**Agenda note for 32<sup>nd</sup> Meeting of the Standing Committee on Power System Planning in Northern Region.**

**1. Confirmation of the minutes of 31st Standing Committee on Power System Planning in Northern Region held on 02/01/2013**

**7. LILO of Sikar-Neemrana 400kV D/c line at Babai(RRVPNL) :**

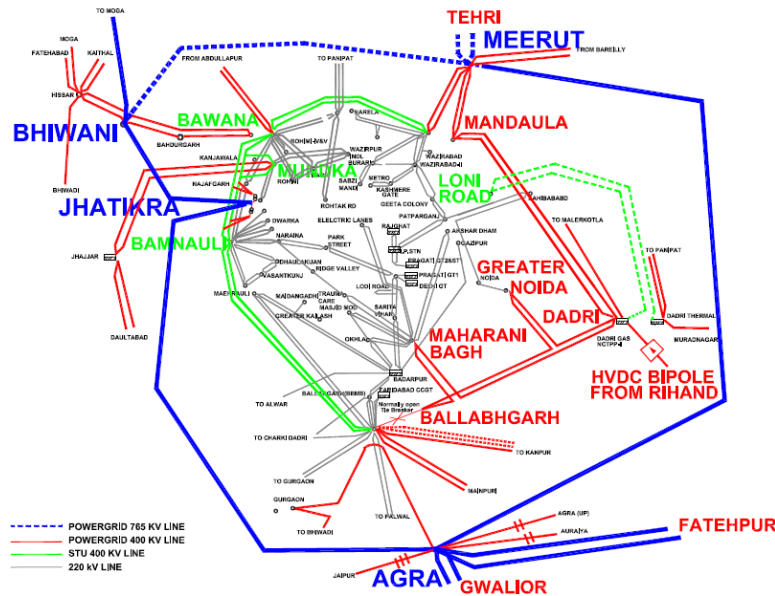
RRVPNL vide its letter dated 17/01/2013 (copy enclosed at **Annexure-VII**) has proposed “*LILO of one ckt of Sikar-Neemrana 400kV line at Babai would help in enhancing the reliability of power supply to Delhi/NCR region*” Here it may be mentioned that Babai(near Khetri) is a under construction 400/220kV substation of RRVPNL under associated transmission system for Suratgarh Super Critical TPS (2x660MW) and is to be connected to Suratgarh through 400kV D/c line. Simulation has been carried out to study the effect of proposed LILO of Sikar-Neemrana at Babai. Study results are enclosed at **Exhibit-IV(a) & (b)**. Both Babai and Sikar are connected to Suratgarh TPS and Jaipur. Hence LILO Sikar-Neemrana at Babai results in off-loading of Sikar-Babai section of this line. Further it may be seen from study results that LILO of one circuit also causes unbalanced loadings on Sikar-Neemrana lines. In view of this, proposed LILO of Sikar-Neemrana line at Babai does not appear to be appropriate.

**Modified UPPTCL Evacuation System for Lalitpur STPS (3x660 MW)**

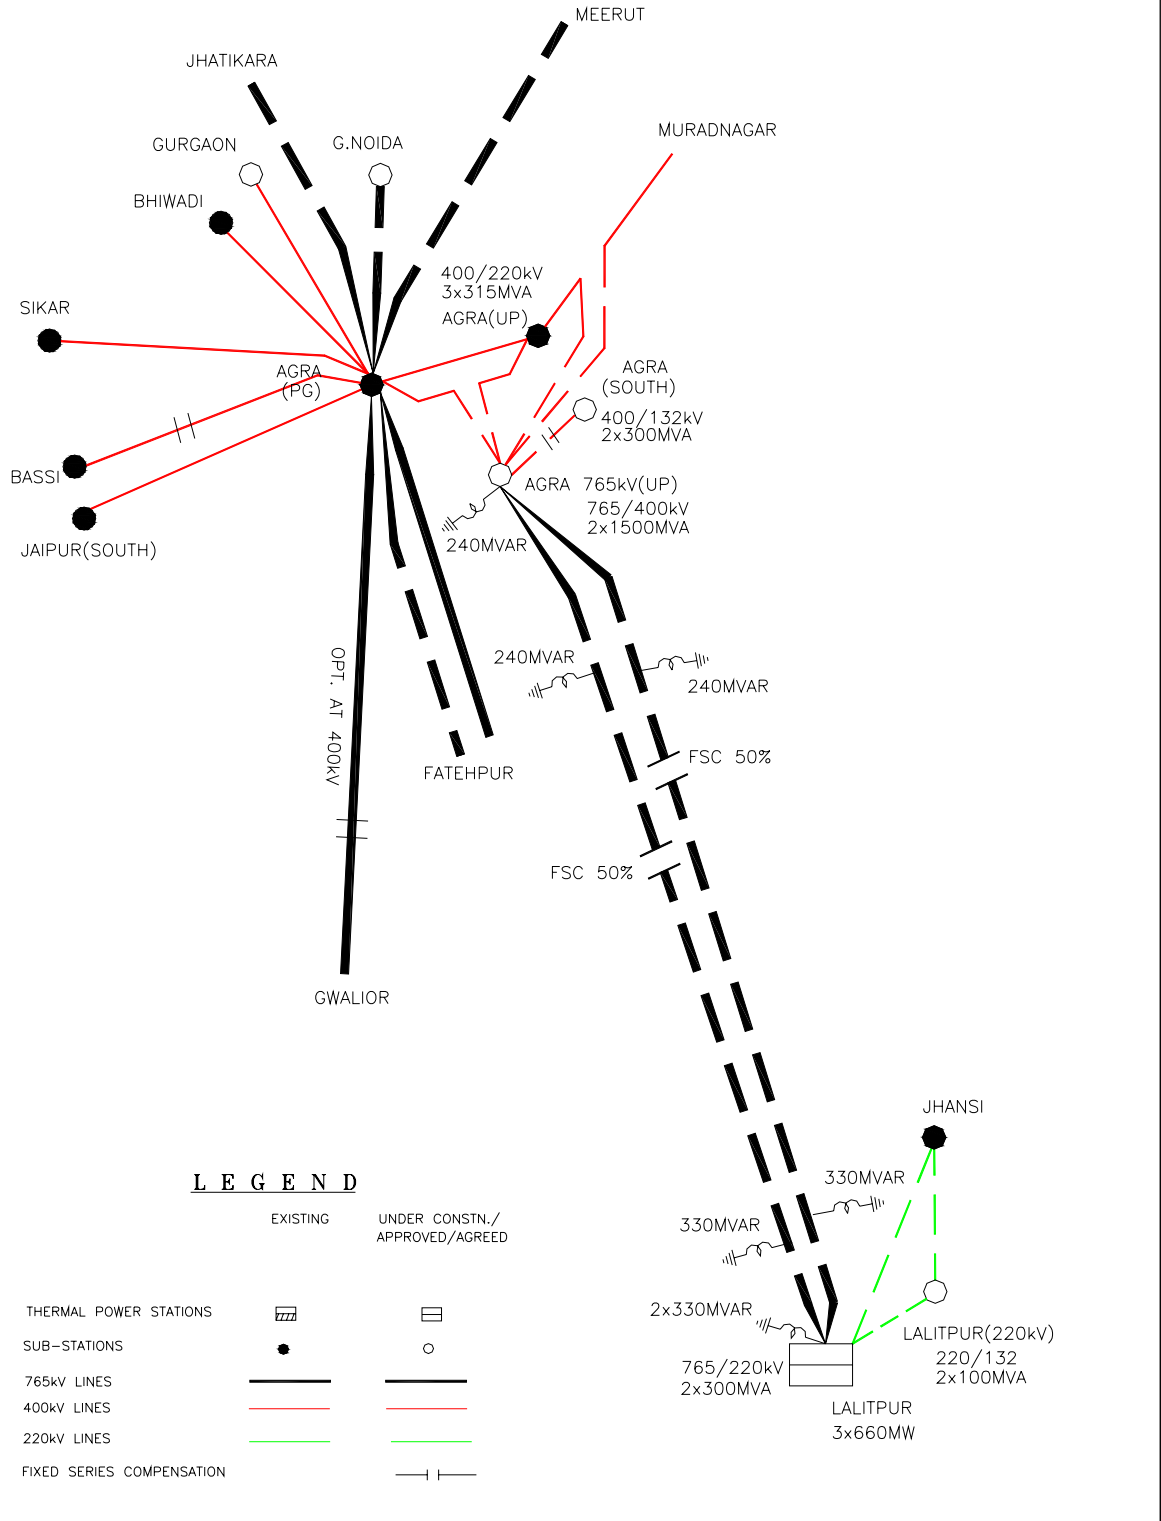
12. The schematic diagram of the revised evacuation system for Lalitpur (3x660 MW) Station is given in **Exhibit-II**.
13. **In view of the above findings, the following recommendations may be adhered to:**

- (i) **50% Fixed Series Compensation (FSC) in 765 kV Lalitpur-Agra (UP) 2xS/c lines along with SSR protection in Lalitpur Generating Plant.**
  - (ii) **An additional requirement of 1x330 MVar 765 kV bus reactor (2nd) at 765 kV Lalitpur generation switchyard in addition to the provision of bus and line reactors as proposed by UPPTCL (Item-2x above). For charging of 765kV Lalitpur-Agra lines, it would be preferable to make it from Agra end.**

**Plot-1 : Lalitpur Machine angle- with PSS**

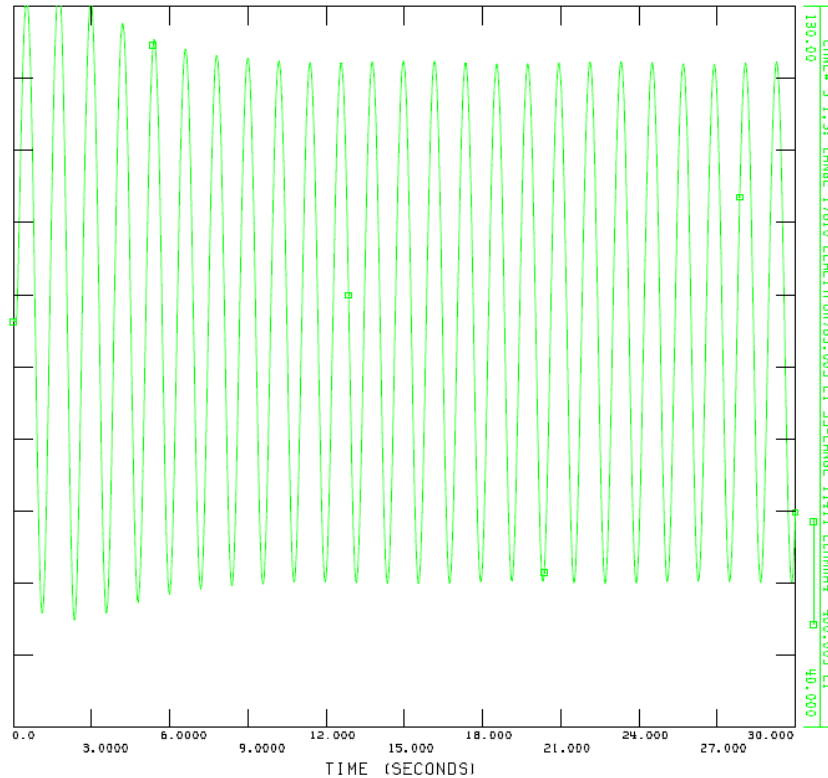
From the studies it is seen that without PSS Lalitpur generators shows undamped oscillations. The PSS model given by CPRI damps these oscillations. However experience has shown that many a times the PSS are not properly tuned. Particularly radially connected machine with long lines shows undamped oscillations. Accordingly, while planning radial generation with long lines proper anchoring is kept always. This has been followed by POWERGRID while planning systems like Sipat, Sasan and Chattisgarh. In the present case also anchoring is required. However in the lack of immediate anchoring the angular stability can be improved by one of the following methods

**Plot-5: Lalitpur Mac. Angle-without PSS- 60% series comp on Lalitpur-Agra 765kV lines**

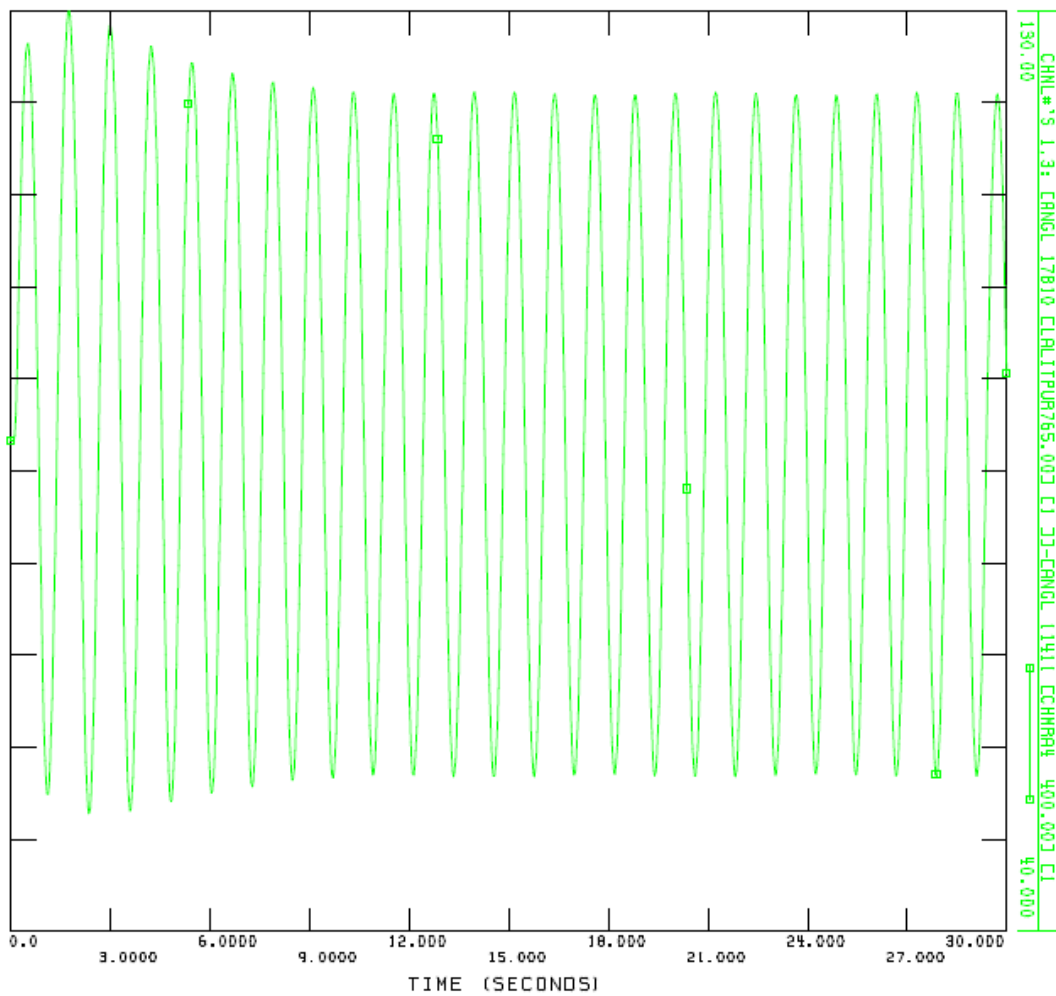
The results indicate that magnitude of oscillation decreases with level of compensation and damping also increases with compensation. However desired damping is not achieved.

**Plot-7: Lalitypur Mac. angle-without PSS- 60% series comp on Lalitypur-Agra & additional Bus reactor at Lalitypur generation**

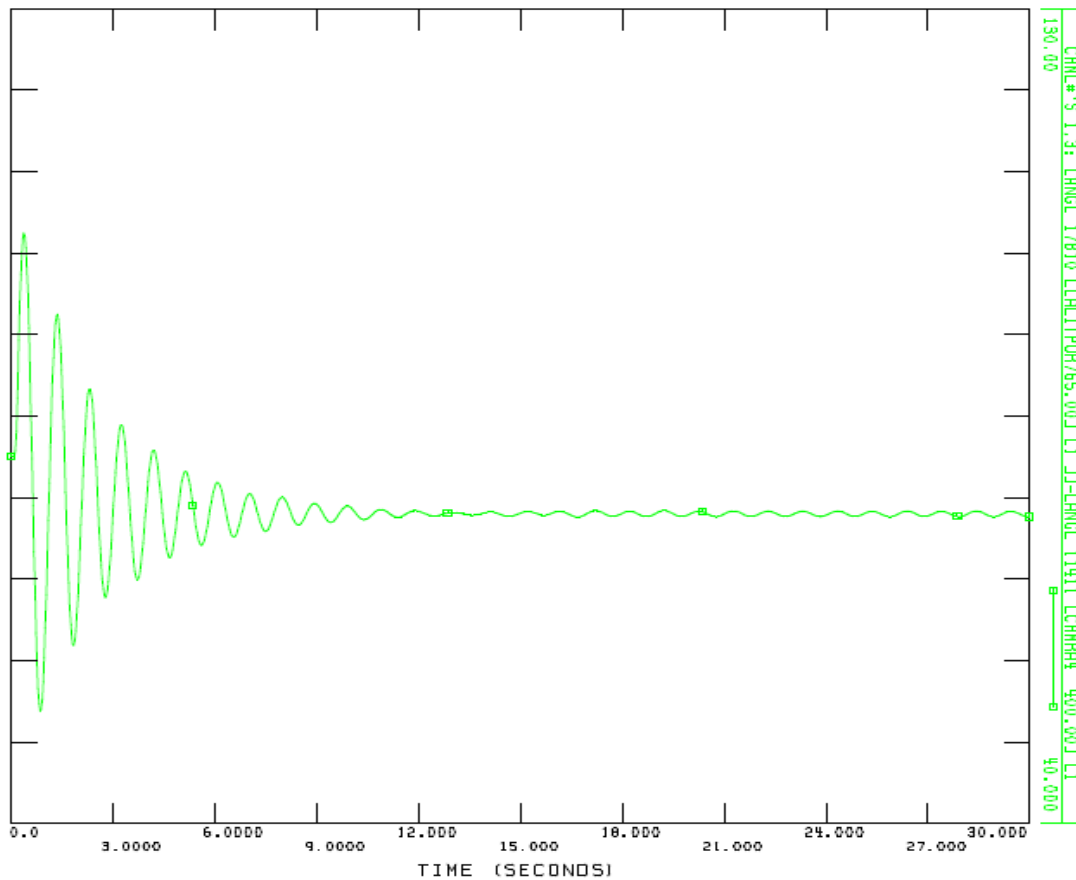
Simulations indicate that with combined effect of series compensation and bus reactor at Lalitpur is more pronounced. With 50% series compensation & above and additional 330MVAR bus reactor at Lalitpur, the desired rate of damping is achieved. Accordingly same is proposed. The supplier for series compensation shall carry out SSR studies and provide adequate protective measures.

With 50% Series Compensation and 330 MVAR Bus Reactor the desired rate of damping is achieved, however there are some minor oscillations. To minimise these oscillations and to improve damping, studies were carried out by with tripping of one unit at Lalitpur through SPS as a secondary protection.
